RE: 3505 Campbell Farm Lane NW
Grading & Drainage Plan
Engineer's Stamp Date: 09/19/23
Hydrology File: G13D045

Based upon the information provided in your submittal received 01/30/2024, the Grading Plans **are not** approved for Grading Permit. The following comments need to be addressed for approval of the above referenced project:

GRADING & DRAINAGE PLAN

C100

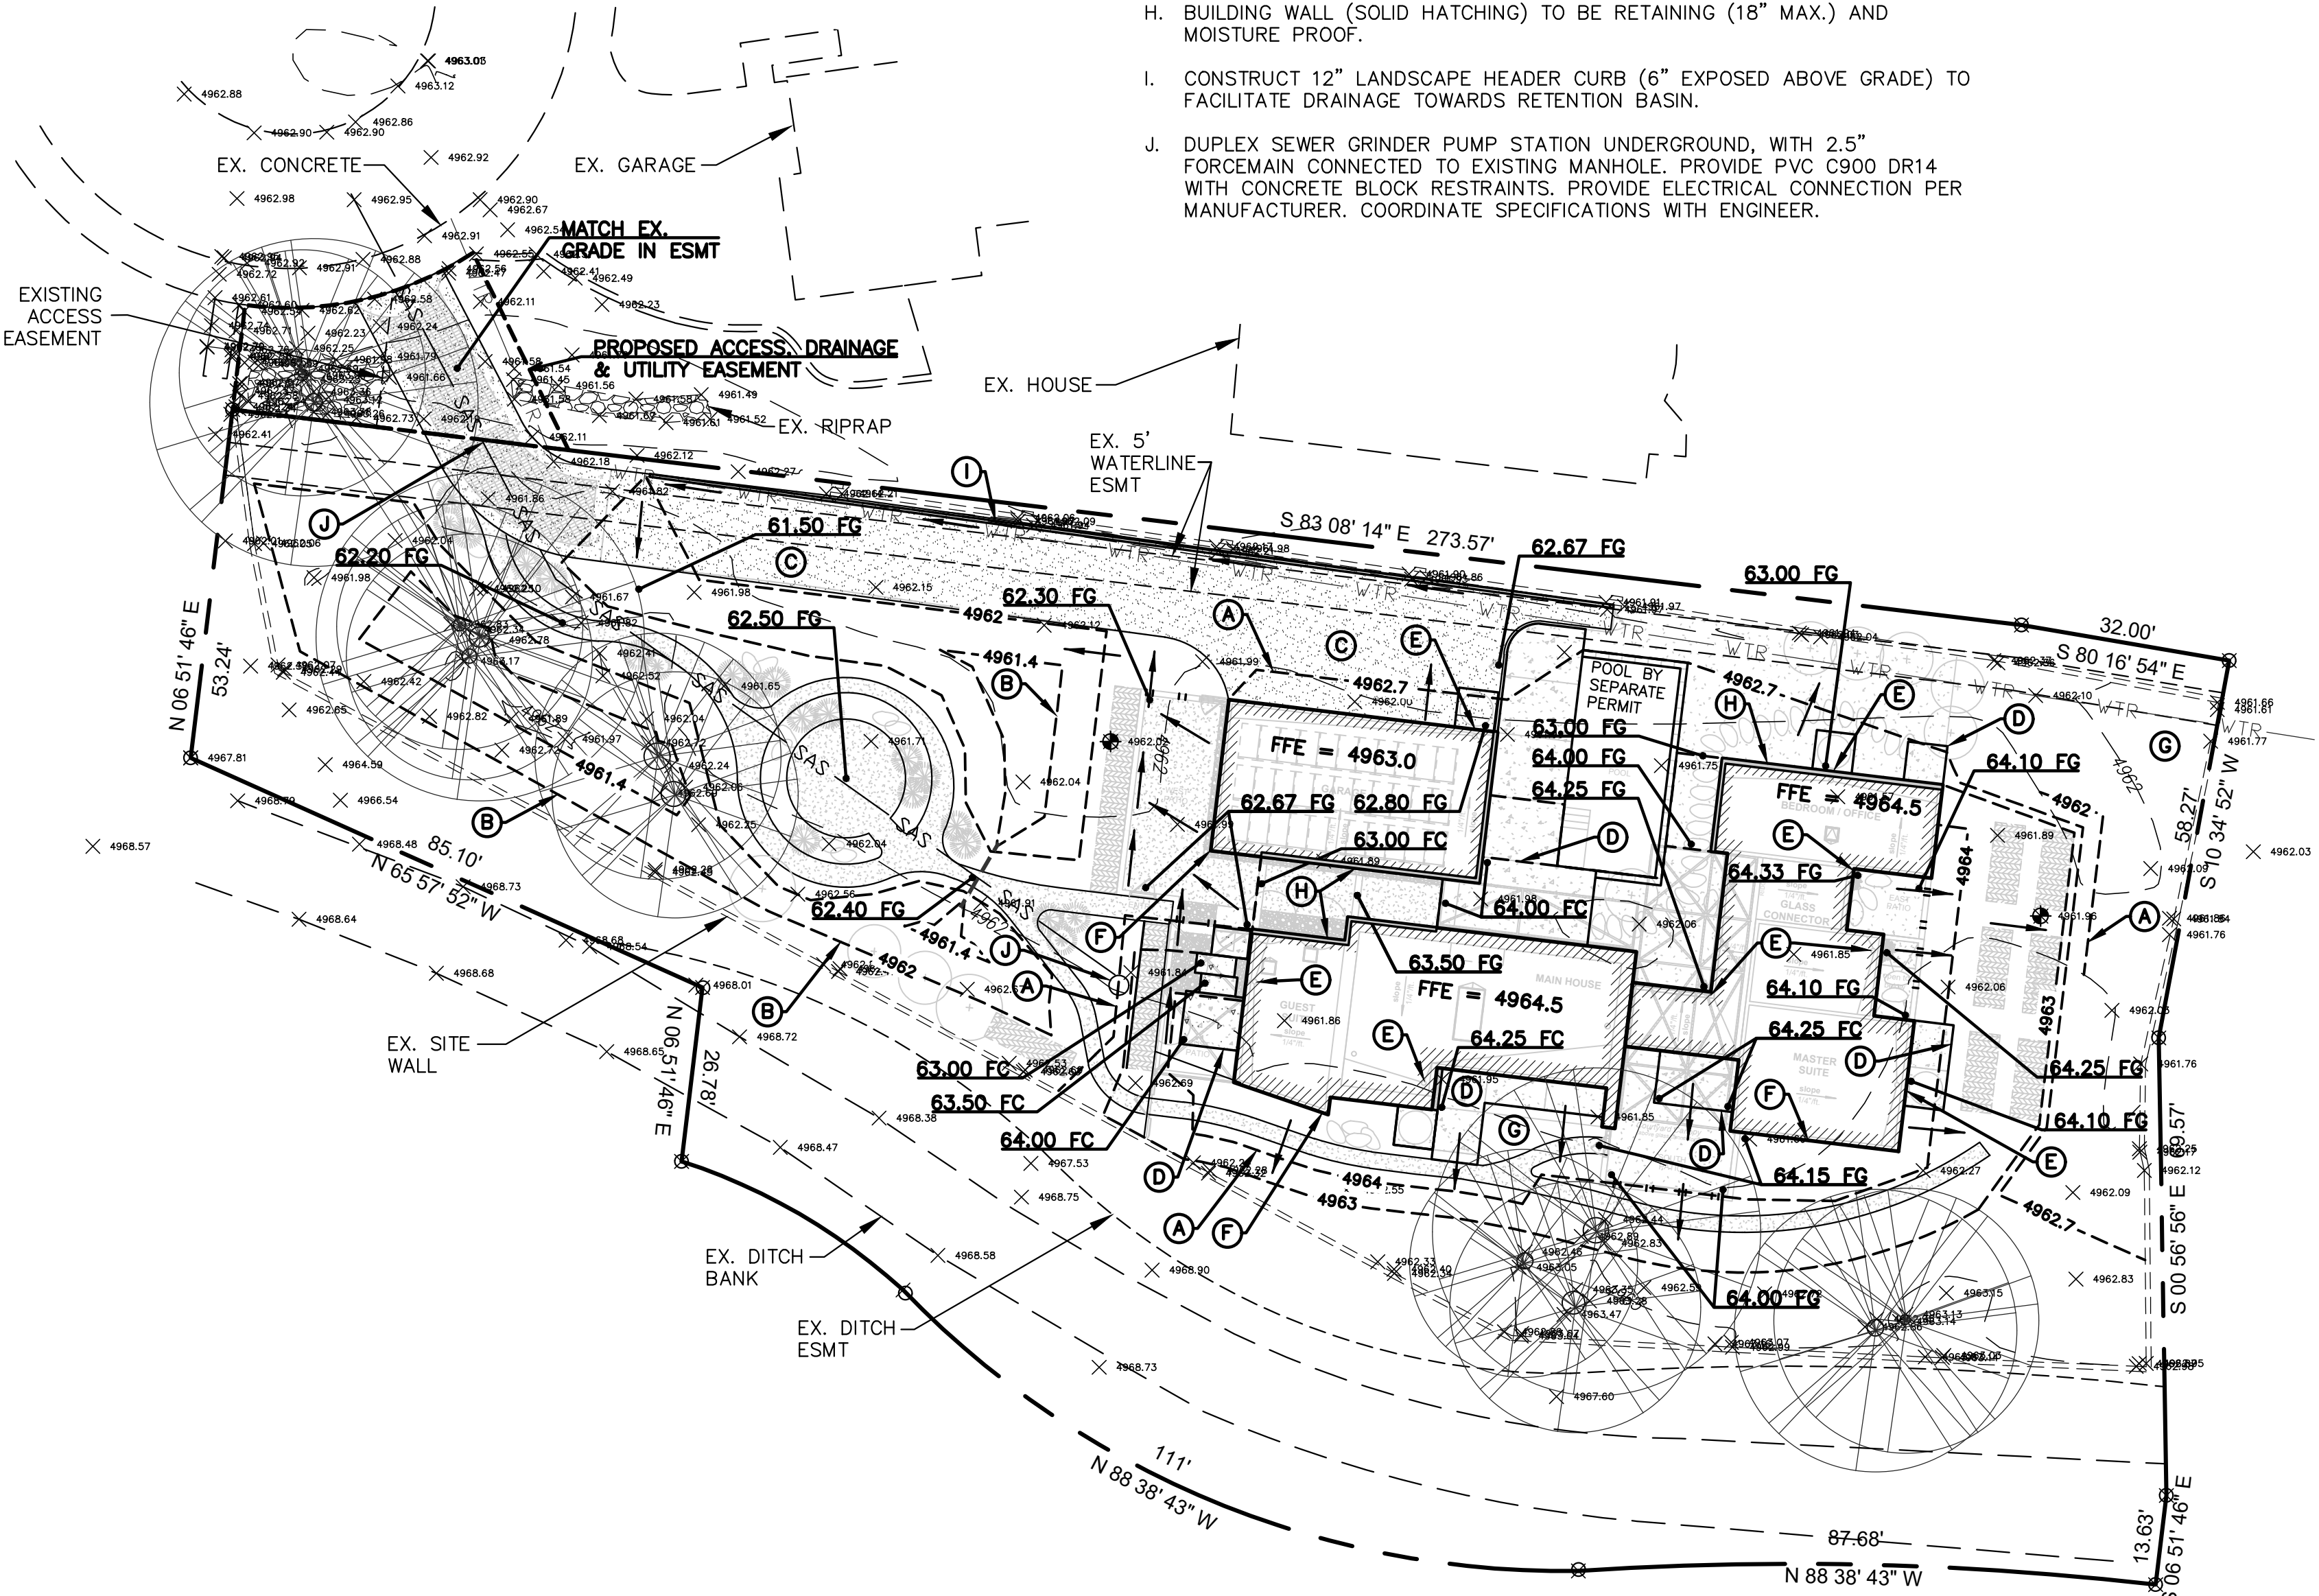
1. Since this site is in the Valley region, please follow Article 6-5 Valley Drainage Criteria of the DPM. The following conditions must be applied to the site:

- The maximum percent impervious of the lot and the contributing area may not be greater than 45%.
- Pad elevation shall be a minimum of one (1) foot above the 100 year 10-day stormwater surface elevation.
- The flow between the front yard and back yard cannot be obstructed. The stormwater must be allowed to equalize to the same level between the front yard and back yard.
- A permanent perimeter wall or barrier around the development is required to contain the 100 year 24 hour storm developed runoff.
- The high point of the street should be four inches above the 100 year 10-day stormwater surface elevation.
